THE GLEN AT WIDEFIELD SUBDIVISION FILING NO. 9

SF-18-005

THE GLEN AT WIDEFIELD SUBDIVISION FILING NO.9 DATE: 04/02/18 SHEET 1 OF 3 DRAWN BY:MWW CHECKED BY: JWT)WG: 17003700FP.DWG JOB NO.: 17003700

dsdlaforce (1)		
New York Carl Carl Carl Carl Carl Carl Carl Carl	Subject: Callout Page Label: 1 Author: dsdlaforce Date: 7/9/2018 8:40:07 AM Color:	SF-18-005
dsdparsons (11)		
	Subject: Callout Page Label: 3 Author: dsdparsons Date: 7/9/2018 10:00:01 AM Color:	Complete notes with reception numbers post recording of fil 8
	Subject: Arrow Page Label: 3 Author: dsdparsons Date: 7/9/2018 10:00:26 AM Color:	
ANY INT ANY WINE Note: Not	Subject: Callout Page Label: 3 Author: dsdparsons Date: 7/9/2018 10:03:32 AM Color:	Where is the rest of Tract C? It needs to show the complete boundary and close on the drawing. A second sheet may be necessary. You should be showing the row line work adjacent to tract C-
LEGEND officer unit officer officer officer officer states	Subject: Highlight Page Label: 3 Author: dsdparsons Date: 7/9/2018 10:03:44 AM Color:	
	Subject: Callout Page Label: 2 Author: dsdparsons Date: 7/9/2018 10:14:34 AM Color:	Is ROW / utility easements / sidewalks being dedicated with t

THE GLEN AT WIDEFIELD SUBDIVISION FILING NO. 9

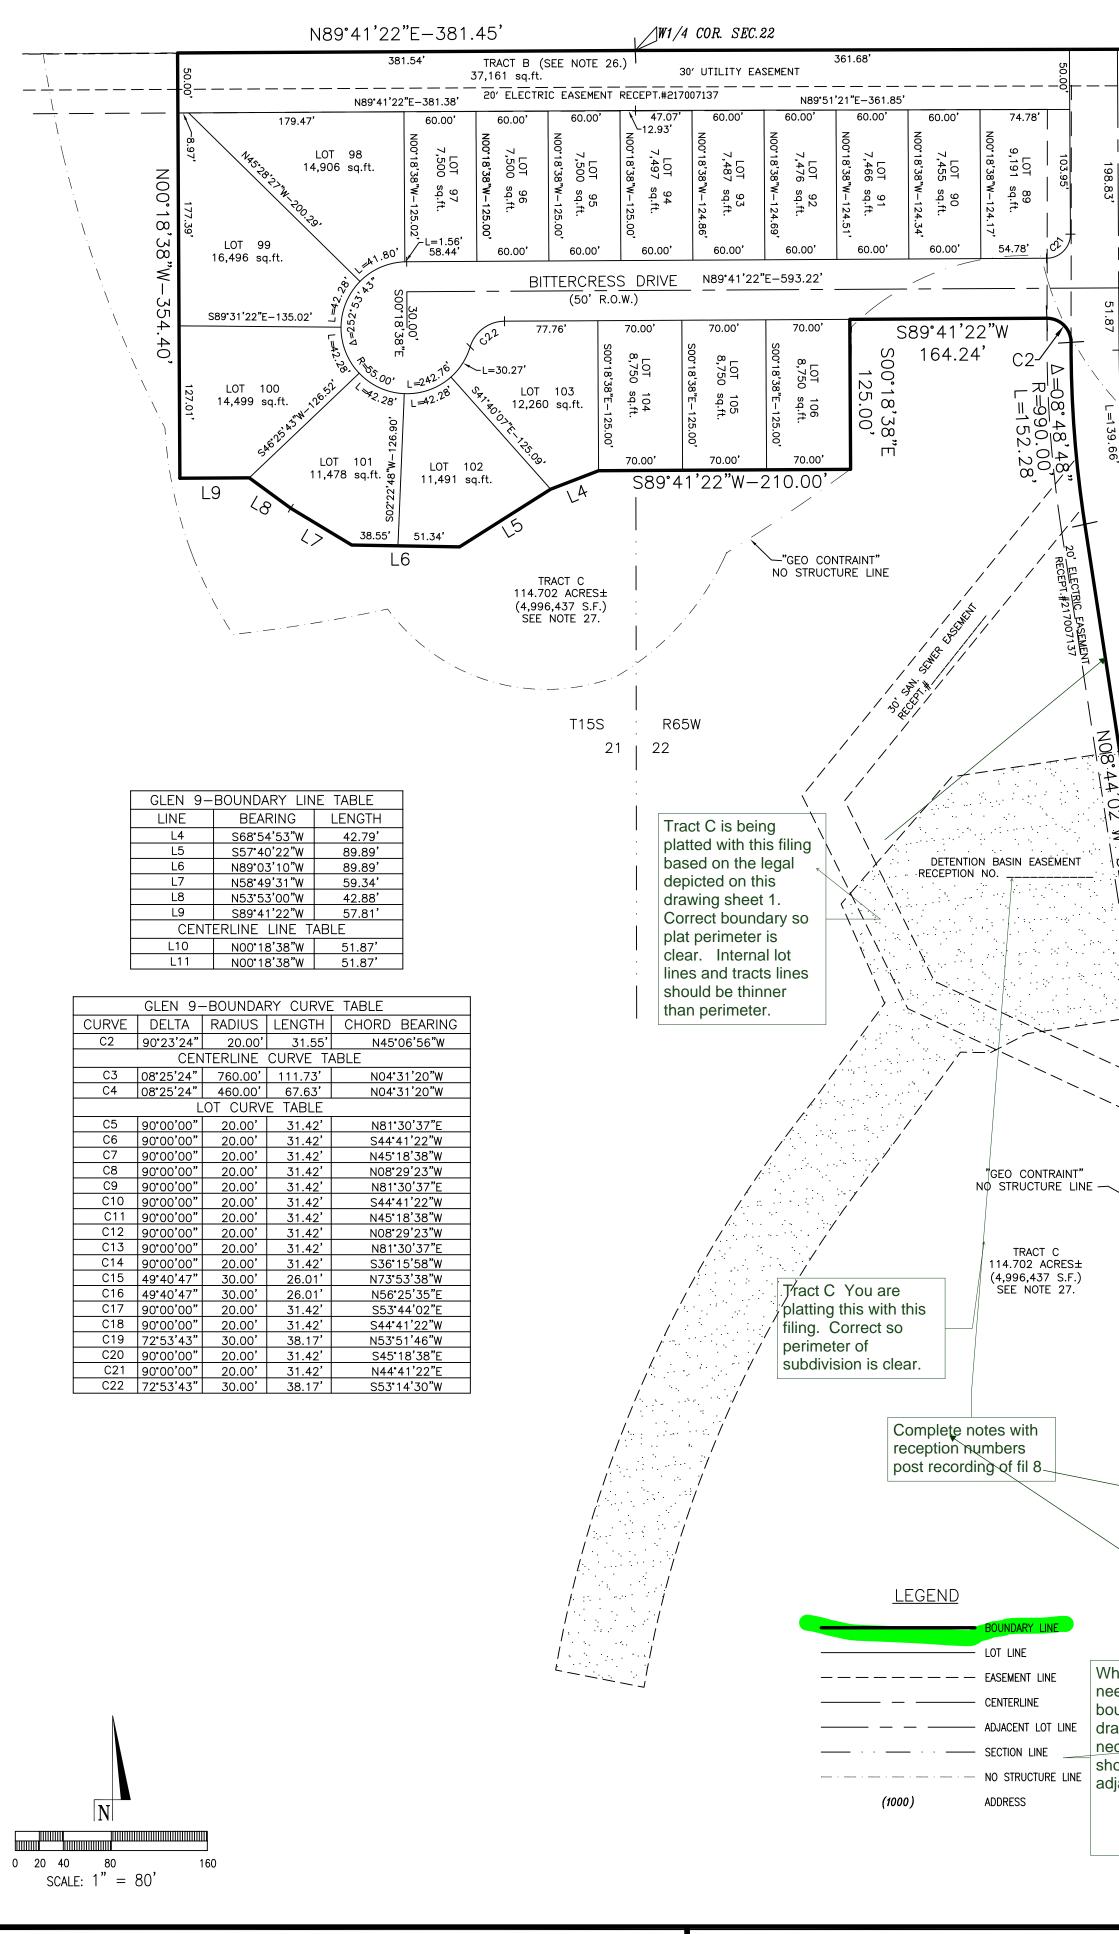
A portion of the Southeast One-quarter (SE1/4), Section 21 and the Southwest One-quarter (SW1/4) of Section 22 Township 15 South (T15S), Range 65 West (R65W) of the 6TH P.M. County of El Paso, State of Colorado N89°51'21"E-1216.92' TRACT A (SEE NOTE 26.) 30' UTILITY EASEMENT 38,960 sq.ft. N89'51'21"E-783.27' 50.00' 145.35' 60.00' 60.00' 50.00' 60.00' 60.00' 50.00**'** 50.00' 52.70 5.18 LOT 7,373 18'7 LOT 7,345 118'38" LOT 118'38" LOT ,335 LOT 136 18'38 LOT 104 18'38 LOT ,383 _0T 447 38"V LOT 097 LOT 77 T 80 5 sq.ft 38*W-1 82 sq.ft 8″₩−1 12,443 sq.ft. 84 8 sq.f 83 sq.ft 3"W-1 79 sq.ft 81 sq.ft sq.f sq. 88 87 87 LOT 76 60.00**'** 50.00' 50.00' 60.00**'** 60.00' 50.00**'** 60.00' 60.00' 50.00' L=37. 11,736 sq.ft. 65.22' 52.70' N89°41'22"E-683.89' BITTERCRESS DRIVE °° N83°36'25"E−111.05 300.00' (50' R.O.W.) 193.89' 190.00' 105.00' 105.00' 67.65**'** 85.00' 6.87' -6.87' 6.87'—- LOT 72 LOT 75 -6.87 LOT 54 LOT 20 LOT 19 10,755 sq.ft. 12,339 sq.ft. 9,120 sq.ft. 9,430 sq.ft. 9,484 sq.ft. S34°08'17"₩−25.78' 7.00' ⁹ S85°27'51"W-123.35' S84*49'22"W-126.18' ' [∠]≫46.20' N86°17'03"E-125.00' L=30.11'-LOT 21 53 7,691 sq.ft. IOT LOT 18 7,804 sq.ft. LOT 71 6,000 sq.ft. 7,807 sq.ft. LOT 74 S81°15'58"W-125.00' N82'03'49"E-125.00' V81°15'58"E-120.00' 13,971 sq.ft. LOT 22 6,250 sq.ft. LOT 52 7,500 sq.ft. IOT LOT 17 ? \$81°15'58"W-125.00' 7.200 sq.ft. 7,609 sq.ft. 581°15'58"W-125.00` 60.0 120.00' 60.00' N81'15' 58"E-N81'15'58"E-125.00 LOT 23 7,500 sq.ft. LOT 51 7,500 sq.ft. LOT 16 6,250 sq.ft. LOT 67 . S81°15'58"₩−125.00' LOT 66 581°15'58"W-125.00` 9.209 sq.ft. 17,258 sq.ft. N81°15'58"E-125.00 LOT 24 6,250 sq.ft. sq. LOT 15 7,500 sq.ft. LOT 50 7,500 sq.ft. ? \$81°15'58"W-125.00' sd 69 N81°15'58"E-125.00' ° 581°15'58"W-125.00' LOT 25 6,250 sq.ft. S81.15'58"W-125.00' LOT 49 6,250 sq.ft. LOT 65 LOT 14 7,500 sq.ft. 11,604 sq.ft. S81°15'58"W-125.00' BALM PLACE <u>N81°15'58"E</u> 195.59' N81°15'58"E-125.00 S77*19'10"E-132.41' LOT 26 7,500 sq.ft. BEE R.O.W.) TRACT D LOT 48 7,500 sq.ft. S81°15'58"W-125.00' 15,000 sq.ft. ん (SEE NOTE 26.) \$81°15'58"W-125.00 LOT 64 LOT 2/ 7,500 sq.ft. 17,640 sq.ft. 47 LOT 47 7,500 sq.ft. S81°15'58"W-125.00' LOT 62 581°15'58"W-125.00' 18,115 sq.ft. LOT 63 LOT 28 6,250 sq.ft. 14,511 sq.ft. LOT 46 6,250 sq.ft. ⊃. S81°15'58"₩−125.00' N81°15'58"E-131.09' LOT 13 \$81°15'58"W-125.00' 7,500 sq.ft. LOT 29 6,250 sq.ft. 8. N81.15'58"E-125.00' 6,554 sq.ft. S81°15'58"W-125.00' LOT 45 7,500 sq.ft. 131.09 LOT 12 7,500 sq.ft. \$81°15'58"W-125.00 LOT 30 7,500 sq.ft. N81°15'58"E-125.00` 1 OT 60 S81°15'58"W-125.00' 10.228 sq.1 LOT 6,250 sq.ft. _20.52').52' LOT 31 6,716 sq.ft. ² N81°15'58"E-125.00' 76°08'41"W-123.76 10 . 6,586 sq.ft. LOT 59.ft LOT 57 🖊 LOT 55 LOT 54 LOT 16 LOT 53 🖊 LOT 17 THE GLEN AT WIDEFIELD SUBDIVISION, FILING NO. 8 Where is the rest of Tract C? It needs to show the complete 、RECEPT.#___ boundary and close on the drawing. A second sheet may be LOT 15 necessary. You should be showing the row line work NO STRUCTURE LINE adjacent to tract C-LOT 14]P.O.B. LOT 13

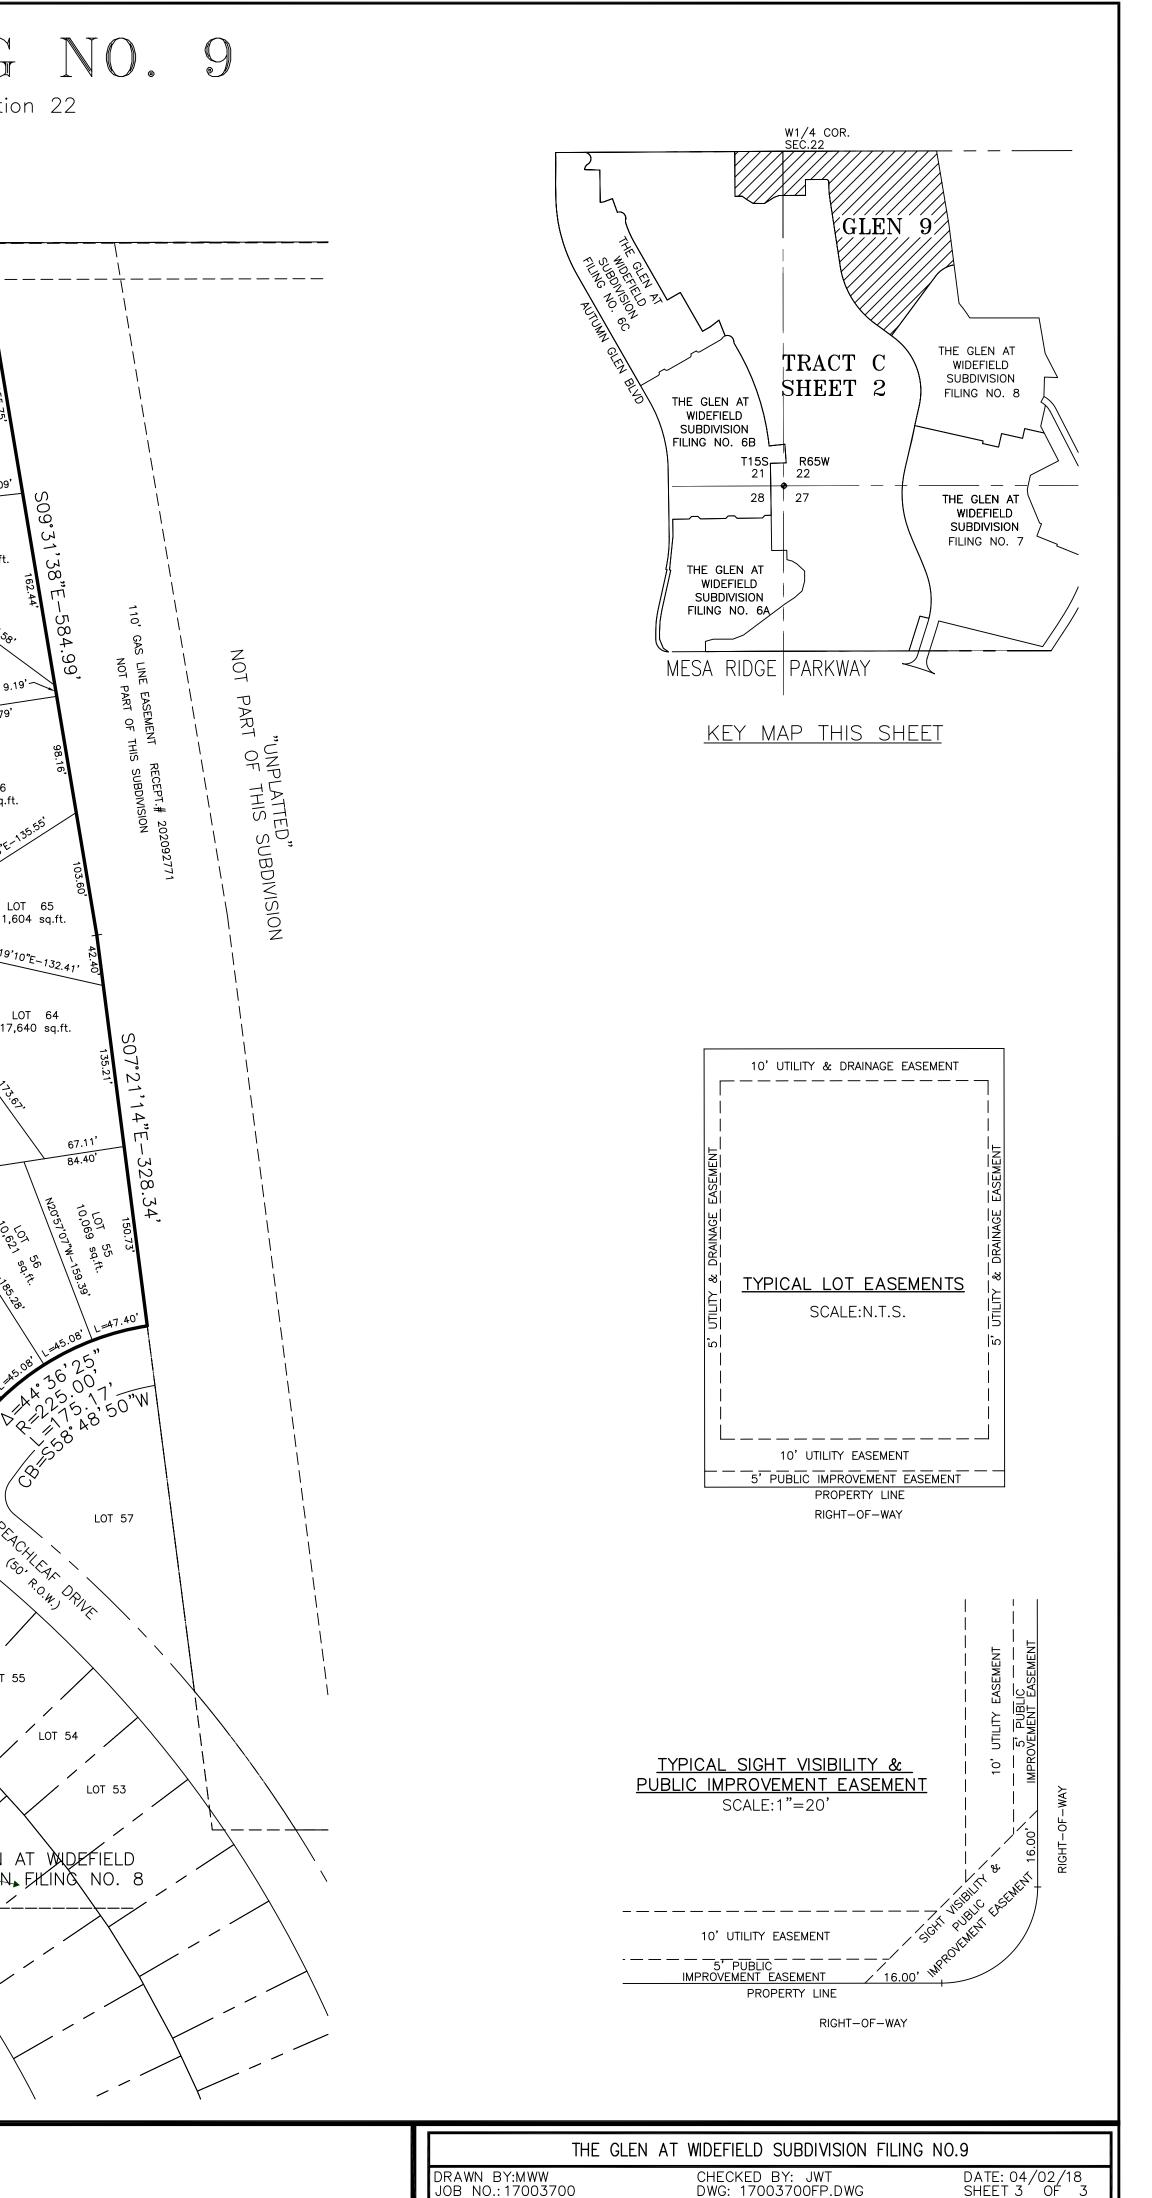
Tract C is being platted with this filing based on the legal depicted on this drawing sheet 1. Correct boundary so plat perimeter is clear. Internal lot lines and tracts lines should be thinner than perimeter.

Tract C with this filing This looks like its not being platted correct boundary so plat perimeter is clear.

Tract C You are platting this with this filing. Correct so perimeter of subdivision is clear.
